**VIA E-MAIL**  
**DOCKET@ENERGY.STATE.CA.US**California Energy Commission  
Dockets Office, MS-4  
Re: Docket No. 12-IEP-1B  
1516 Ninth Street  
Sacramento, CA 95814-5512

Re: 2012 Integrated Energy Policy Report Update/Demand Forecast: Comments of Pacific Gas and Electric Company on the Draft Staff Report *Revised California Energy Demand Forecast 2012-2022, Volumes 1 and 2***I. INTRODUCTION**

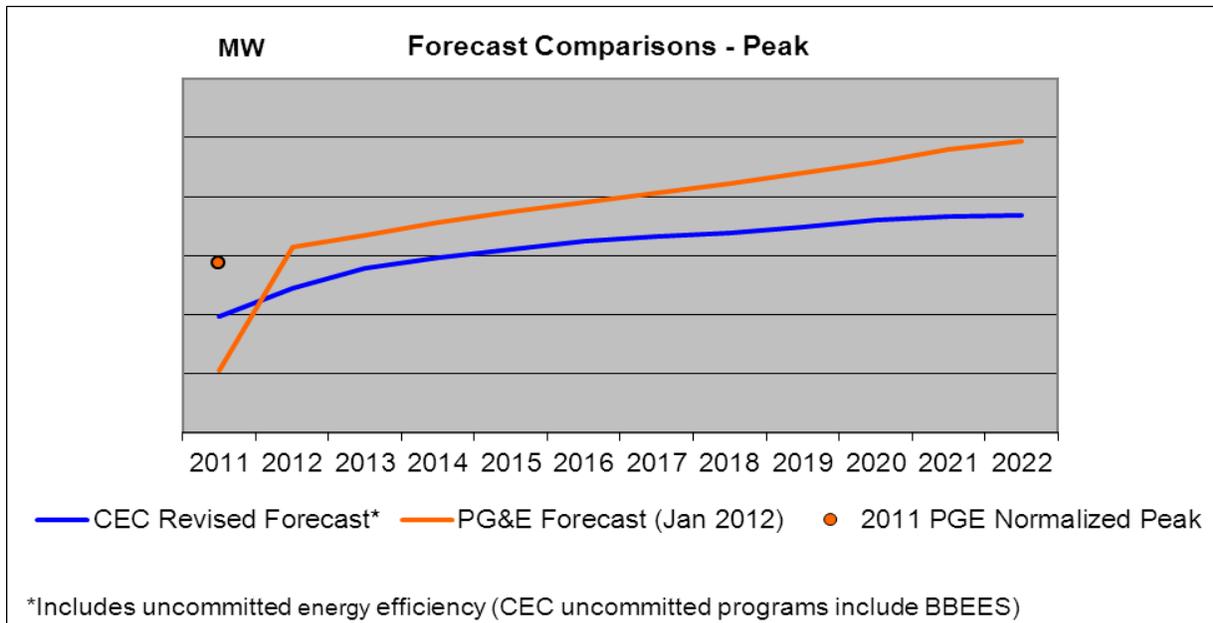
Unusually mild summer-time temperatures in 2011 resulted in an annual peak anomaly for the PG&E service area. Not only was the peak observed in June (about a 1-in-10 year occurrence), but the peak itself was just an average (1-in-2 normal) peak for the month of June. PG&E’s analysis suggests that this peak was nearly 2,000 MW below what would be considered a normal annual peak. The observed peak of 18,024 MW is estimated at 19,868 MW on a normalized basis. PG&E is unclear as to the CEC’s approach to normalizing the 2011 peak, and needs to better understand whether staff is taking the observed peak and normalizing it, or using its existing forecast models to generate a temperature normal peak value for 2011. Either way, the staff approach projects a normal 2011 peak at 18,965 MW – 900 MW below PG&E’s weather-normalized peak value for 2011.

The importance of this starting point discrepancy becomes apparent when PG&E's forecast and the CEC forecast are shown side-by-side, as on the graph below. (In this graph, the two forecasts are shown on a comparable basis, i.e., the CEC forecast is adjusted to include uncommitted energy efficiency.)

As can be seen, the respective starting points go a long way in explaining the difference in the forecasts in 2022. In fact, the difference in starting points (903 MW) is three-fourths of the difference in 2022 (1,247 MW).

Understanding differences in temperature adjustment can be a fairly detailed exercise in modeling approach and statistics, and PG&E understands that at this point in the IEPR process, a discussion of this type may be too involved to effect a change to the forecast. However, PG&E does recommend that at a minimum, the CEC should clarify its estimate of the 2011 data point in its forecast process for this IEPR cycle. If PG&E and staff can come to an understanding as to the value of the 2011 peak, much of the forecast differential could possibly be reconciled.

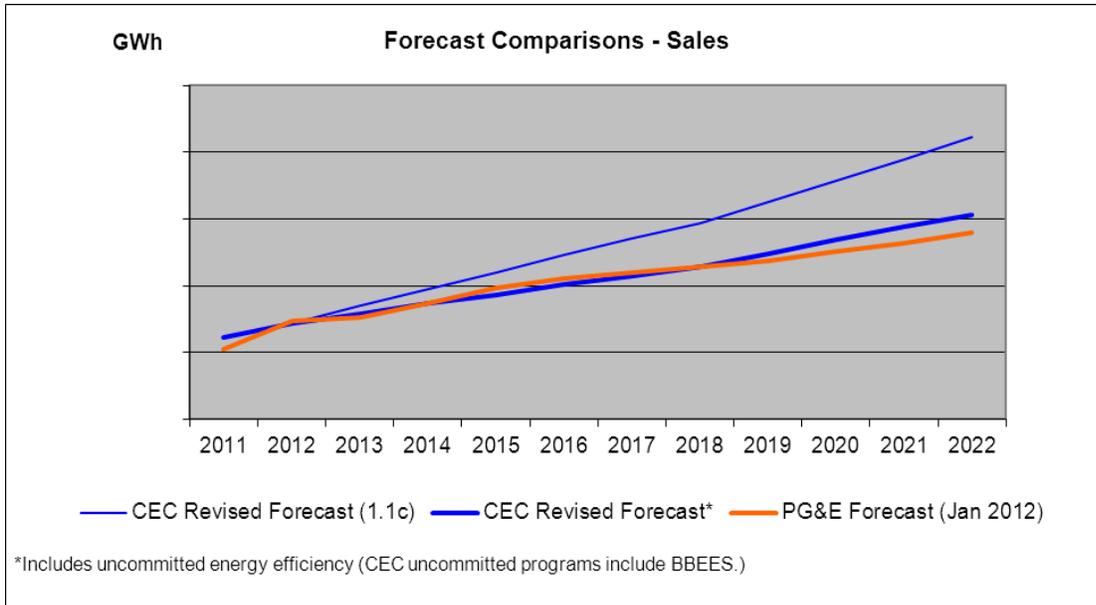
In contrast to the peak discussion above, PG&E has no real issues concerning the sales forecast. On a comparable basis, the forecasts of PG&E and CEC line up fairly closely, with about a 1,000 GWh difference in 2022 (a little over 1 percent). The graph below, however, does visibly show how significant the inclusion of uncommitted energy efficiency is. This is an issue that others have also raised, so PG&E will not add to that discussion here, only to point out that the inclusion of uncommitted EE reduces usage by about 5,000 GWh in 2022.
